TOWN OF ACTON

APPLICATION FOR PERMIT TO CONSTRUCT WITHIN A PUBLIC WAY

Subject: Keyspan Energy Delivery, Carlisle Road & Blueberry Path

We have reviewed the petition from Keyspan Energy Delivery to install a 4-inch gas main in Carlisle Road from Marshall Path to Canterbury Hill Road (Robbins Mill Estates Subdivision) and a 2-inch gas main in Blueberry Path from the end of the existing gas main next to the driveway for house #5 to Canterbury Hill Road. We have the following comments concerning the petition:

TYPICAL SECTION WITH A GRASS STRIP

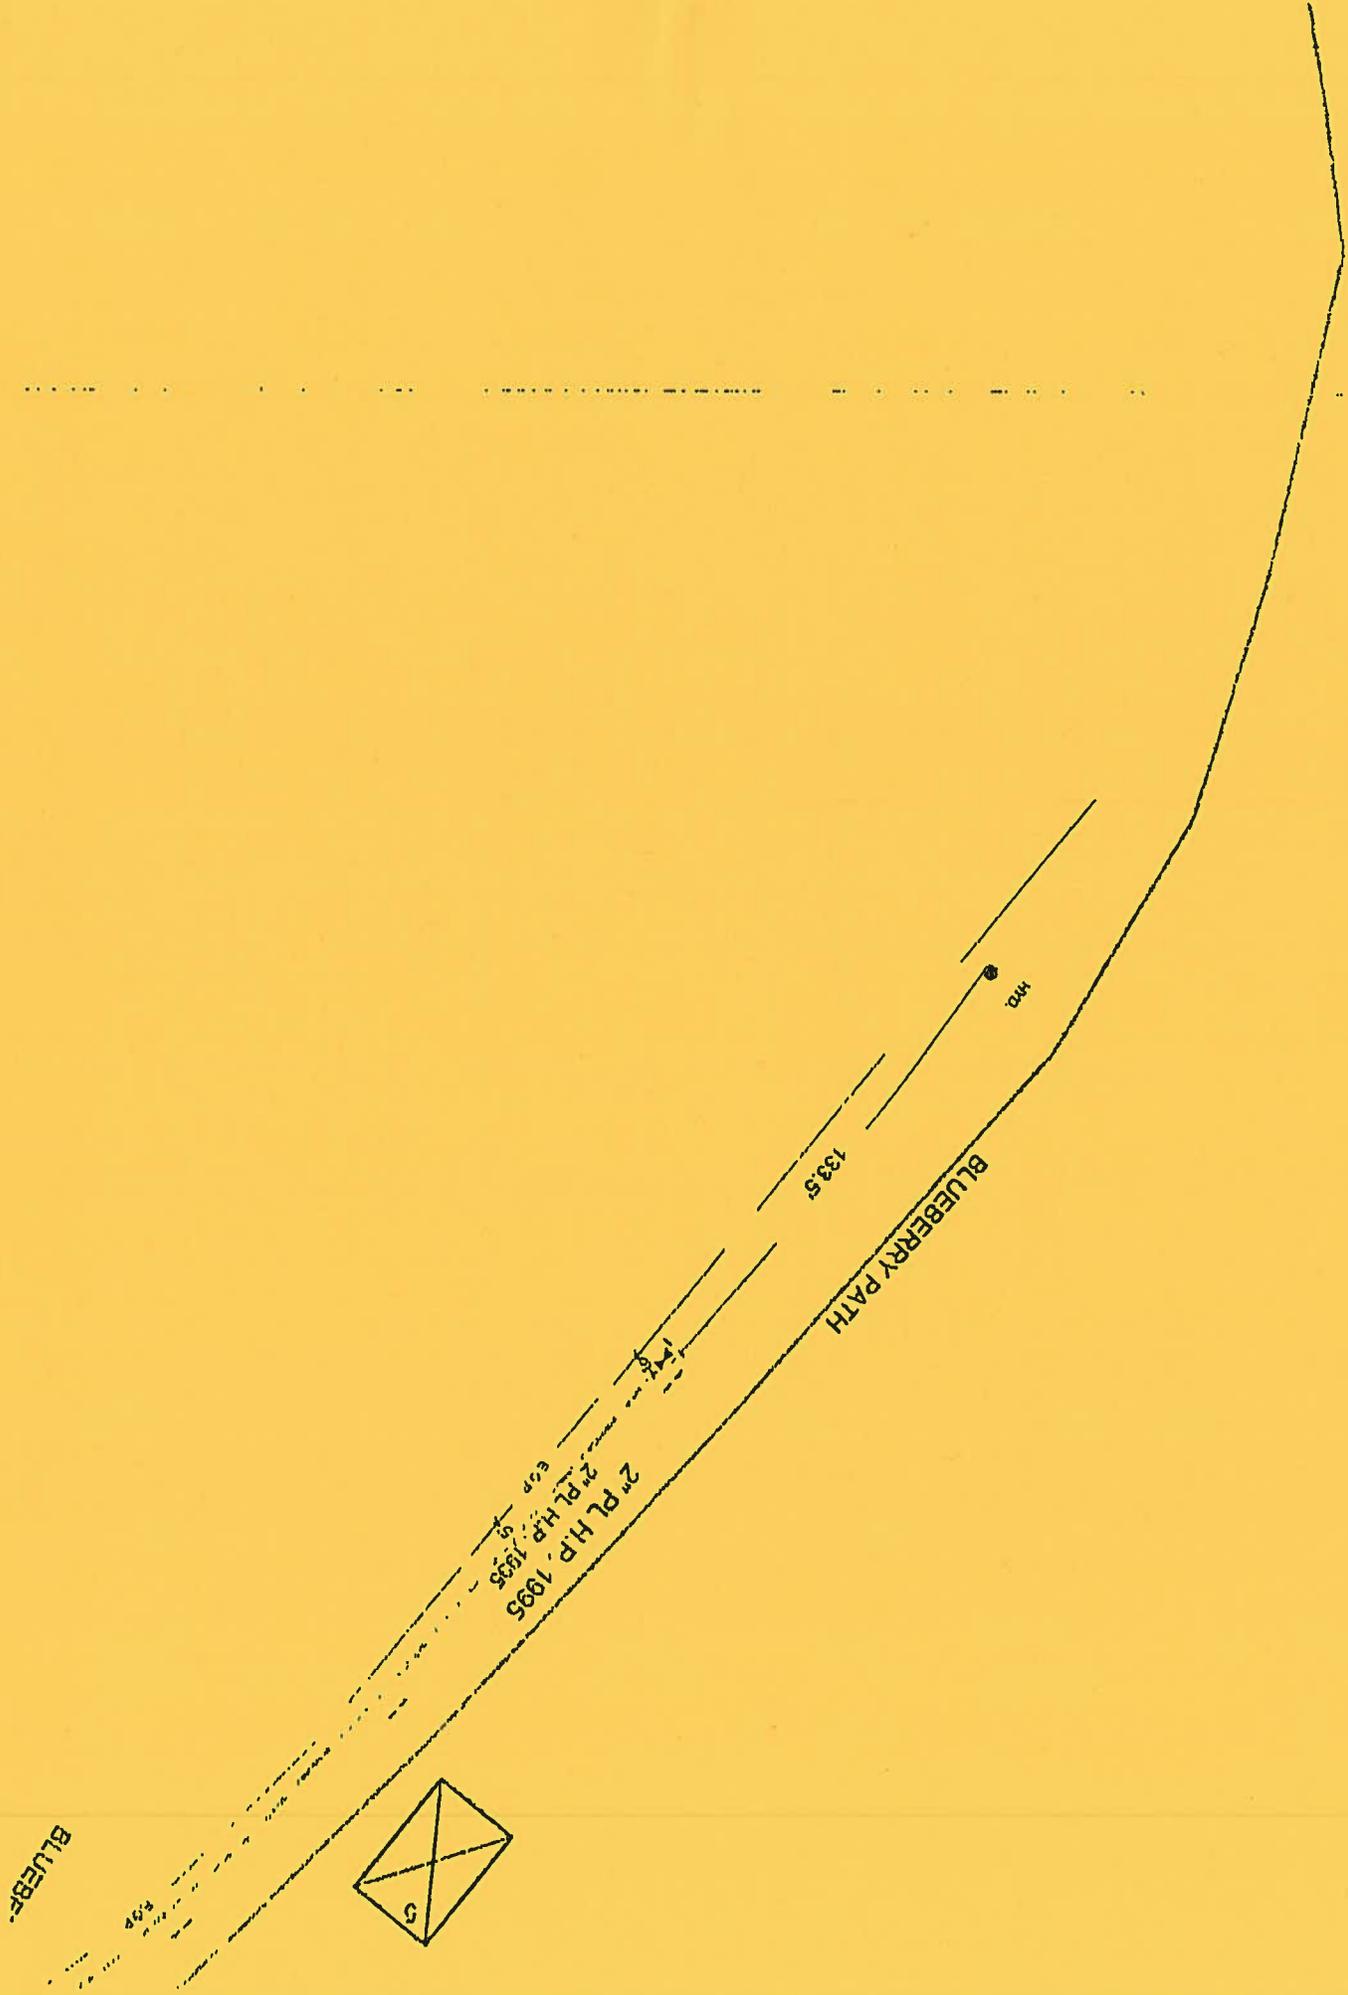
1. We recommend that Keyspan extend the gas main underneath the existing sidewalk along Blueberry Path to avoid working within the road pavement. Once the gas main is installed, Keyspan can reconstruct the sidewalk from the sideline of the driveway for house #5 to the existing hydrant at the end of the road. Attached herewith is a typical detail for a sidewalk and a grass strip.

BLUEBERRY PATH

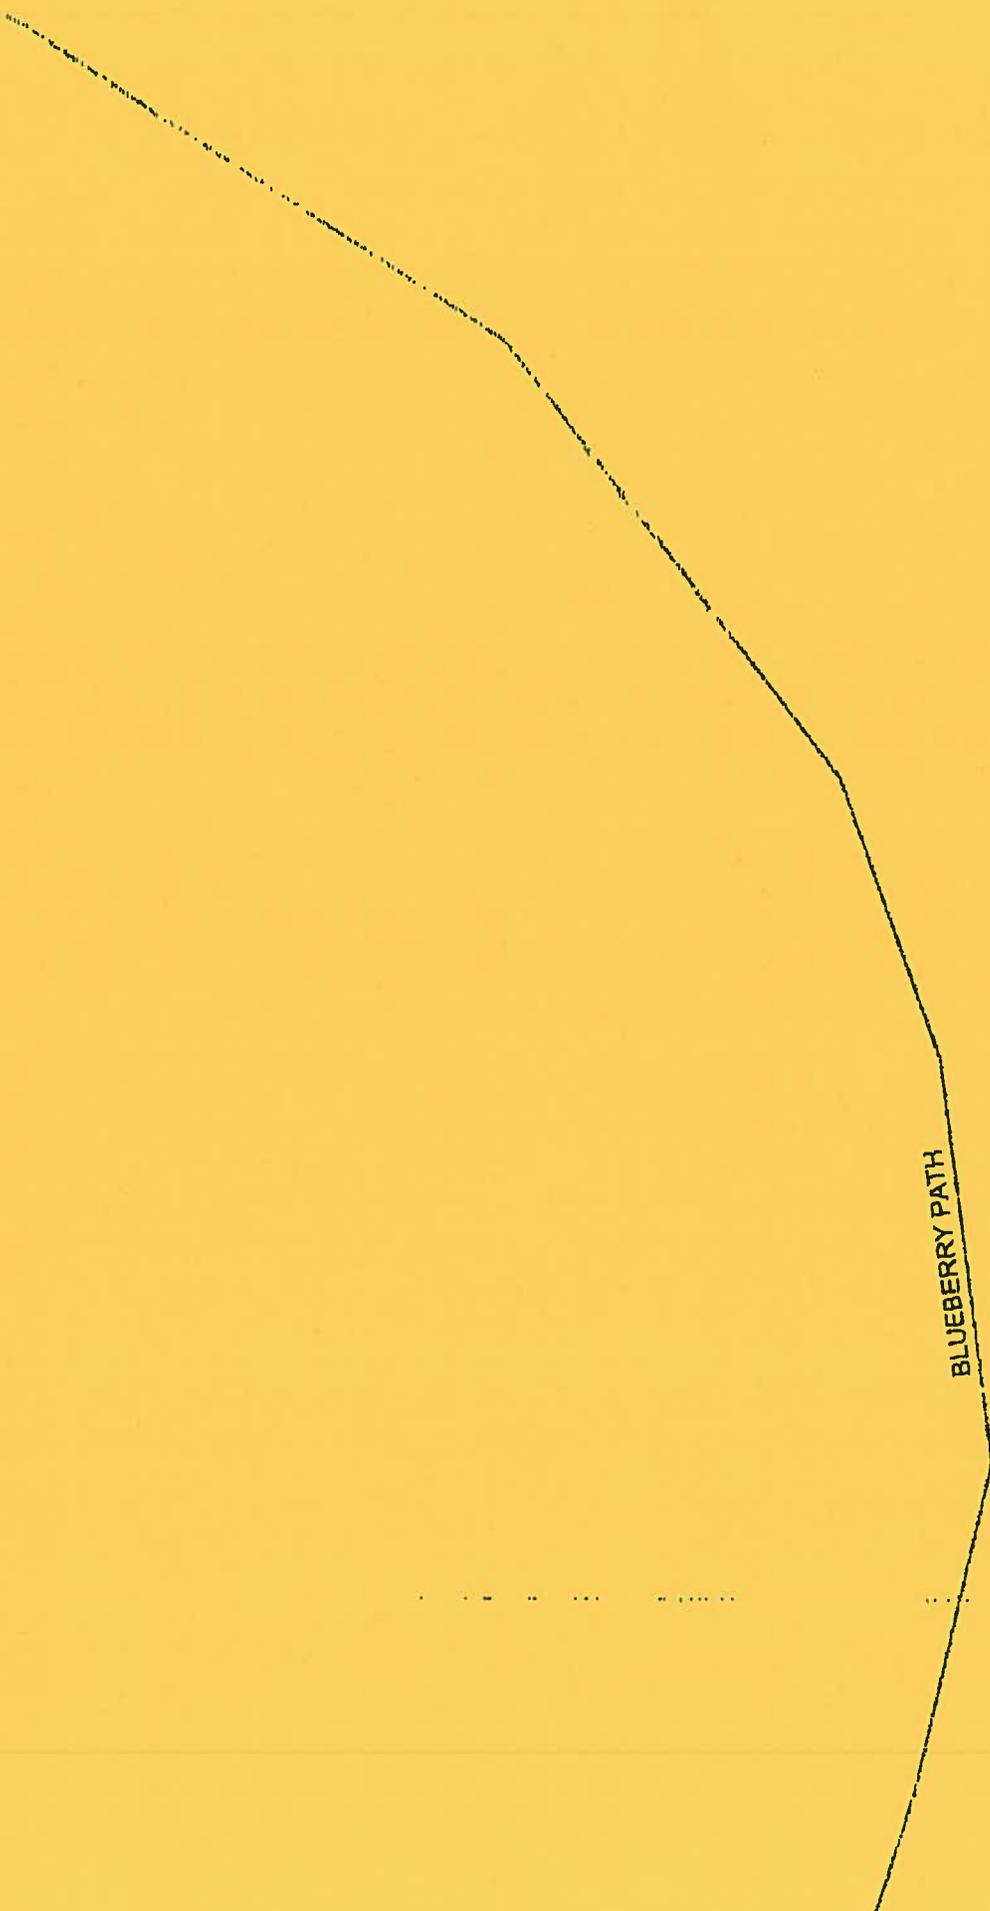
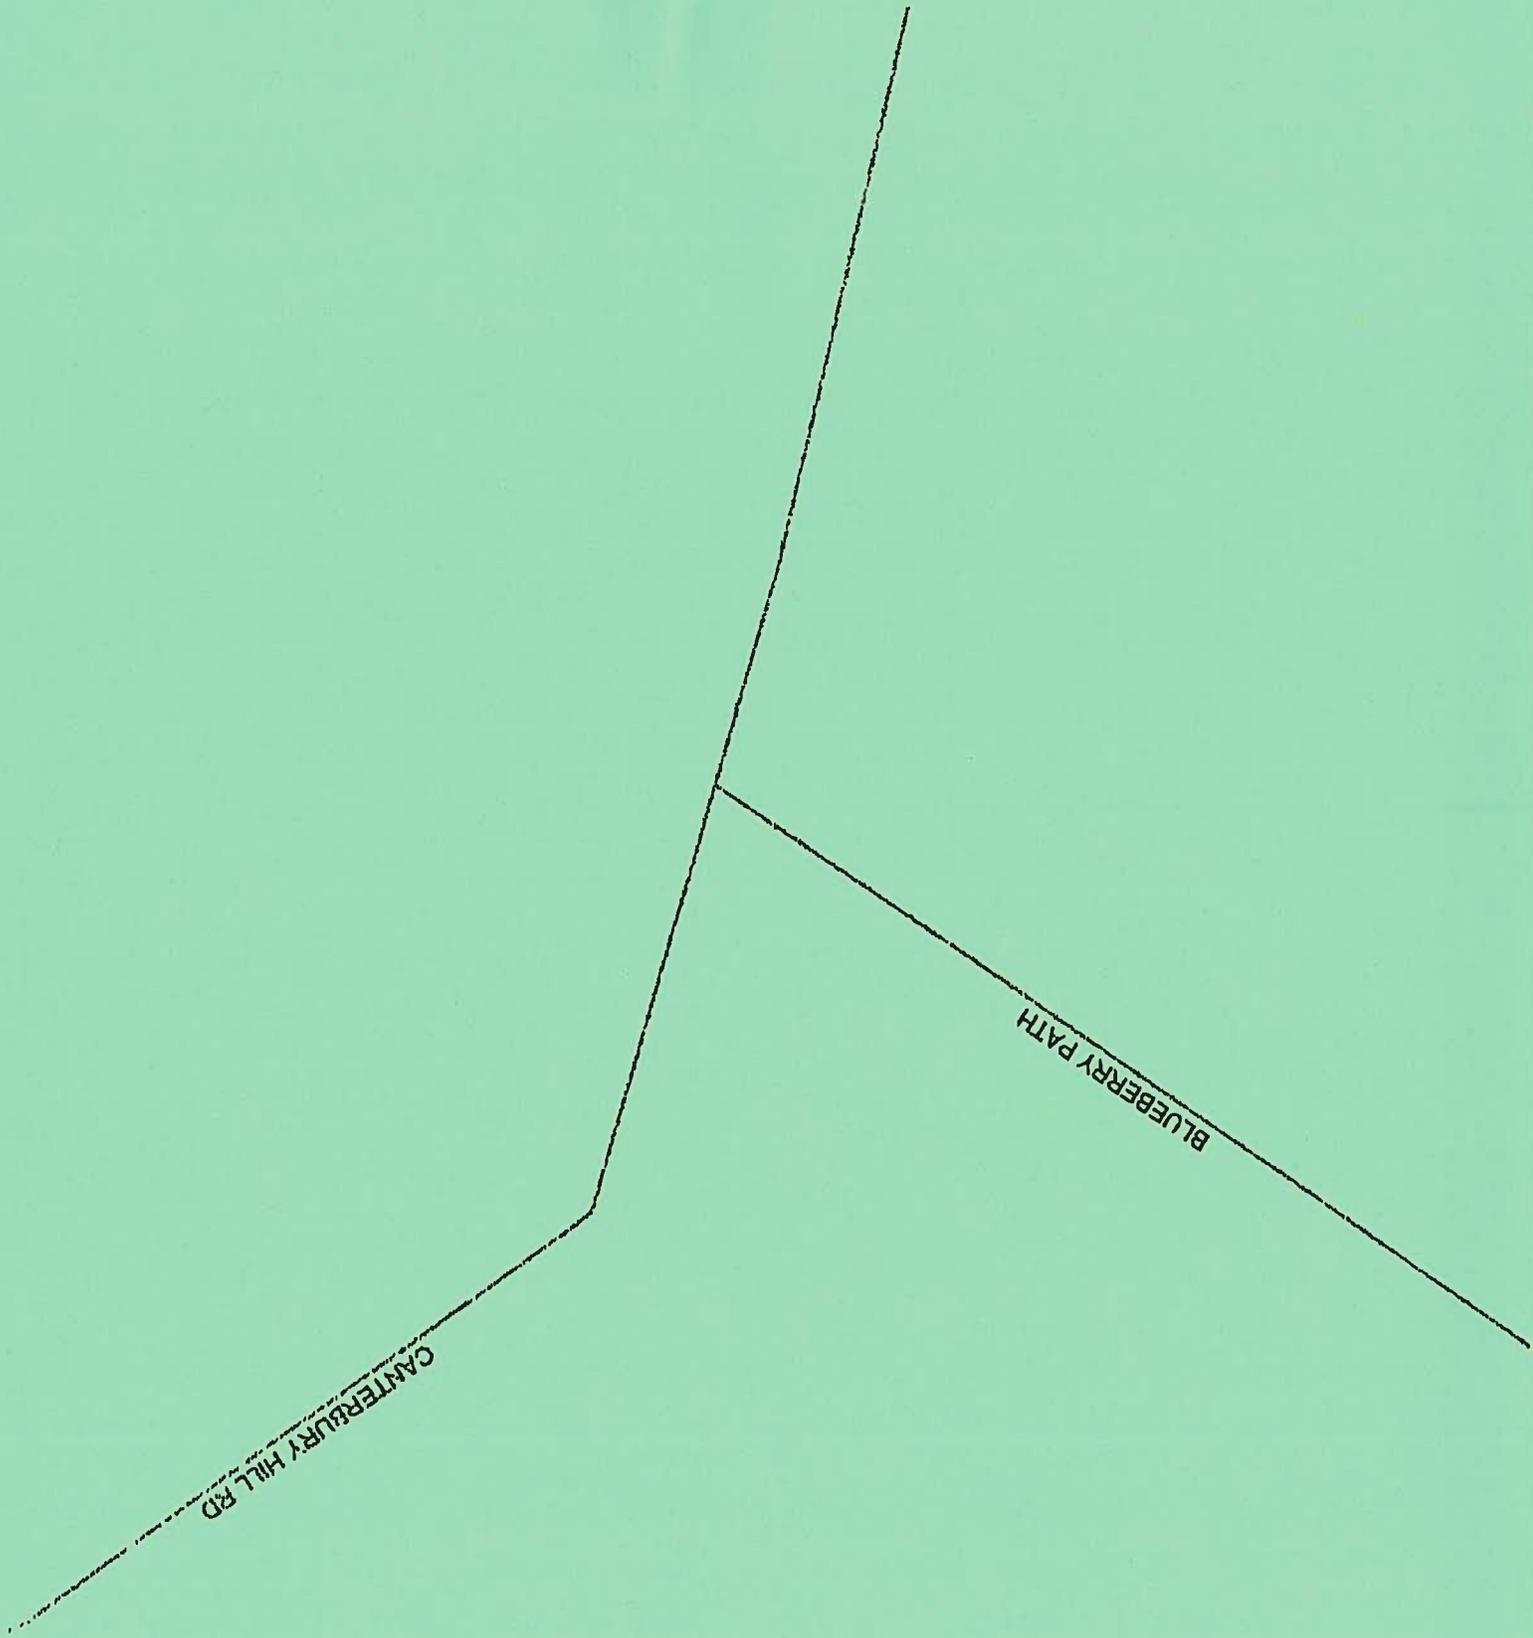
3. I also enclosed a copy of the as-built plan for the Town owned portion of Blueberry Path showing the locations of existing monumentation such as the stone bounds and the drill holes in the stone wall. These survey markers need to be marked in the field and protected during construction. If these survey markers are disturbed during the installation of the new gas main, Keyspan should be required to hire a registered land surveyor to reset and certify the new locations of the stone bound and/or drill holes.
